PLANNING, ZONING, & BUILDING DEPARTMENT
PZ&B Staff Combination Memorandum: Town Council and Architectural Commission

SUBJECT: ZON-24-0067 (ARC-24-0111) 175 BRADLEY PL (COMBO)

MEETING: MARCH 05, 2025 TC
MARCH 26, 2025 ARCOM

Existing front (east) façade

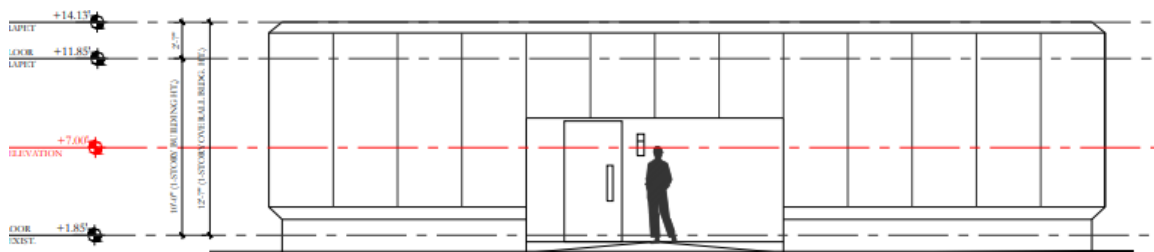
The existing one-story building is a windowless box dressed in a modern Brutalist style. A new second floor addition is proposed to be introduced along with a dramatic makeover of the structure into a more traditional Mediterranean style building. The introduction of ground floor windows with a modern traditional tripartite façade and incorporation of more elements for a pedestrian scale will greatly increase the overall street appeal of the structure with a more welcoming architecture. The second floor will be recessed from the front and rear façade to provide outdoor terraces, a separate side entrance from a private north garden will be designed for the residential unit above.
